ACCESS REPORT

PROJECT: Lismore South Public School – Flood recovery Rebuild
PROJECT NO: GDL 240133
PREPARED FOR: NSW Department of Education (DoE)
REVISION: F
DATE: 06/06/2025

DRAWING : **GROUND FLOOR PLAN**

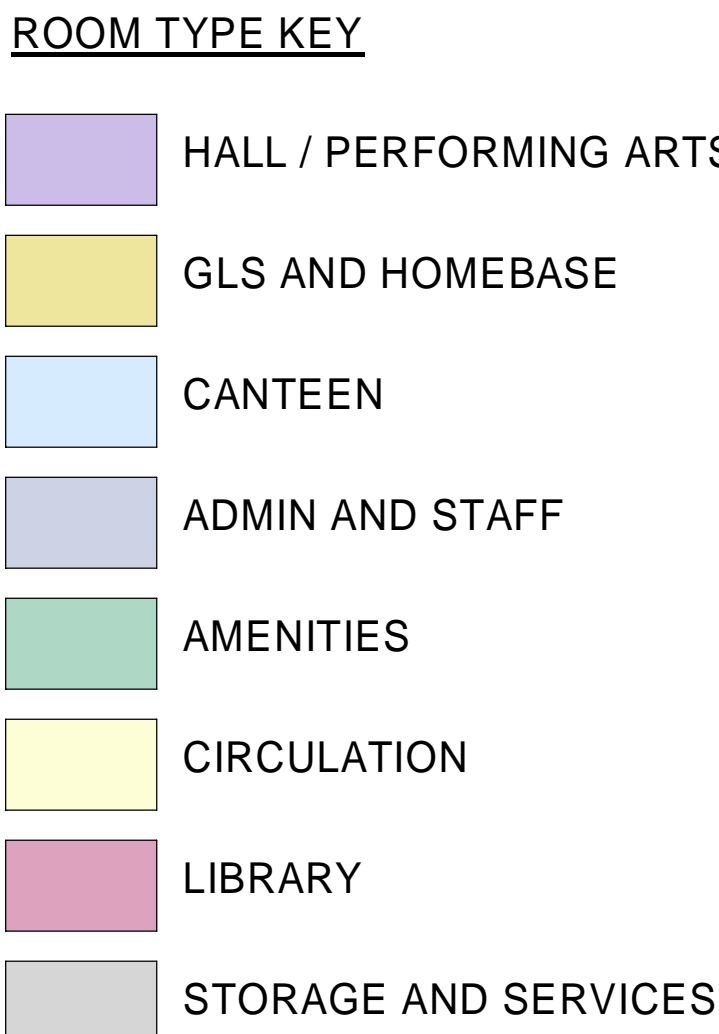
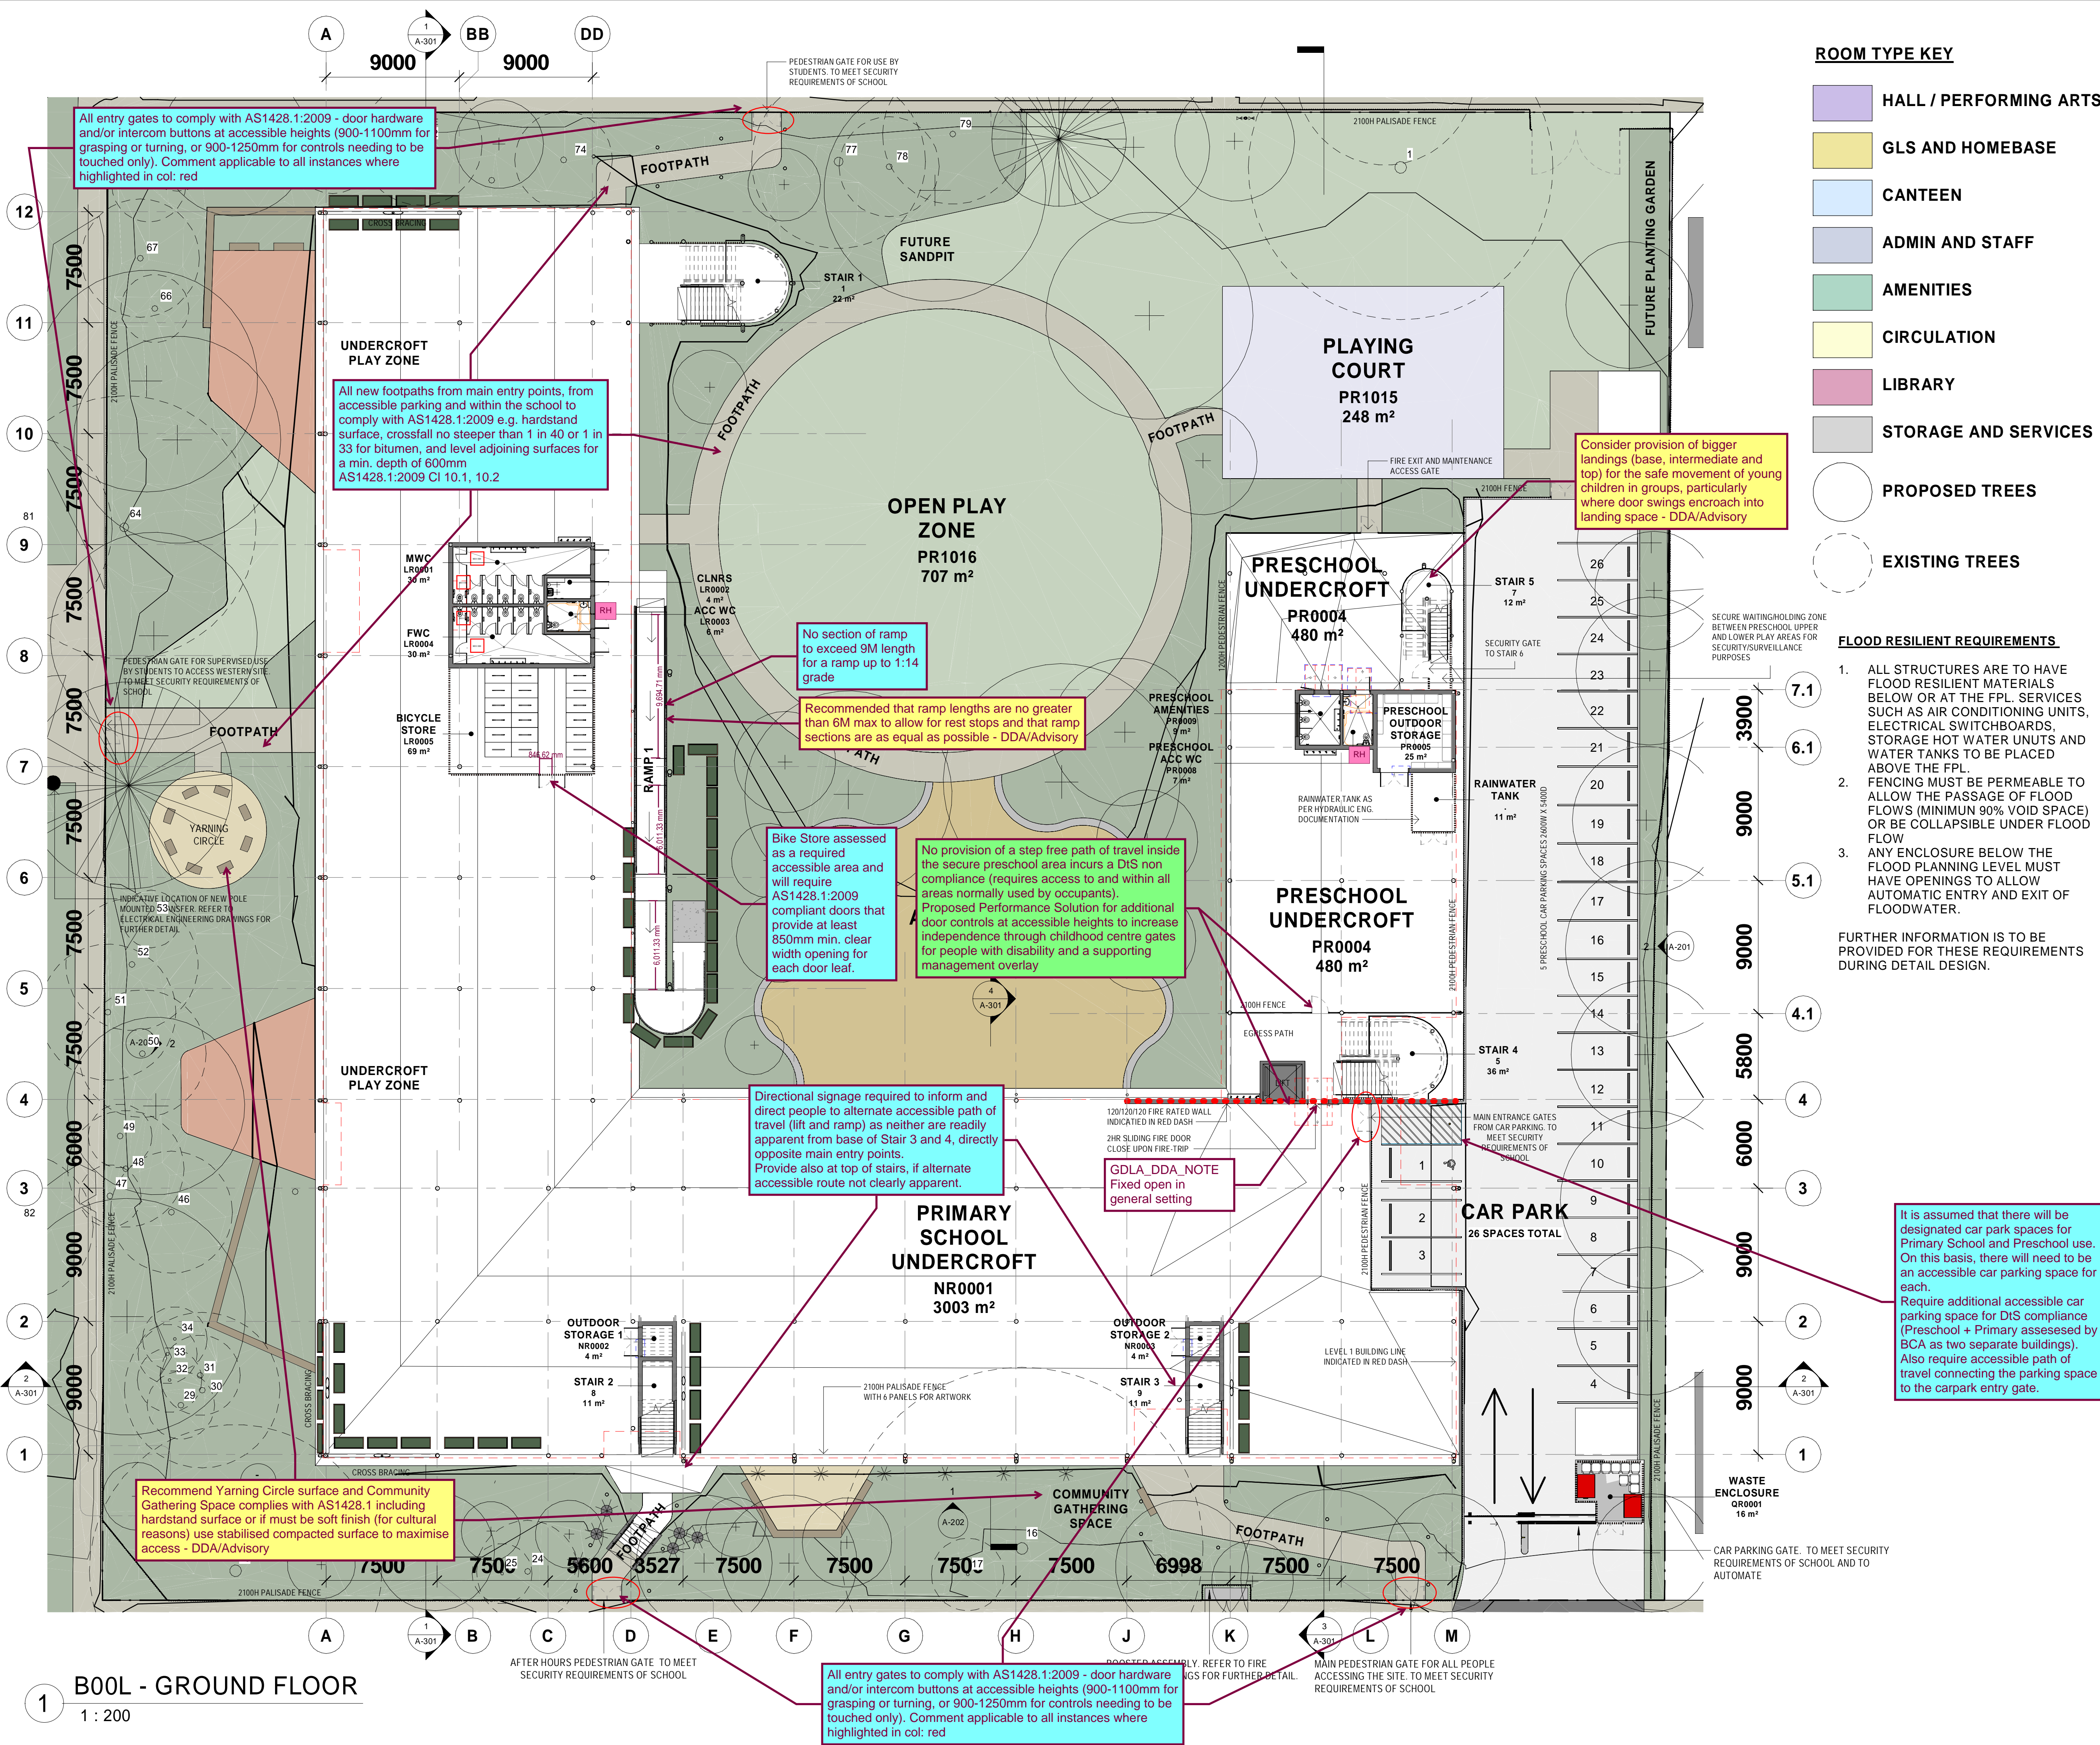
In the event of a fire when the fire doors close on a fire trip, there is no step free egress option for occupants in the Preschool versus Primary School that contains the lift and the external ramp - DDA/Advisory

Surface change bounding walkway to follow the same grade as the walkway and be level for at least 600mm horizontally.
Grade of new footpath to not exceed 1:20.

All new works stairs
to comply in full with
AS1428.1

Kiss and drop zone to contain an accessible drop off zone, as part of a best practice approach.

To be developed in accordance with AS/NZS 2890.6:2009 Cl 2.2.2 and Fig 2.5/2.6, including a minimum 7800mm L x 3200mm W bay and minimum 7800mm L x 1600mm W shared area that is on level surface to the parking space OR has a AS1428.1:2009 kerb ramp.

Location as close to main visitors entry as possible.
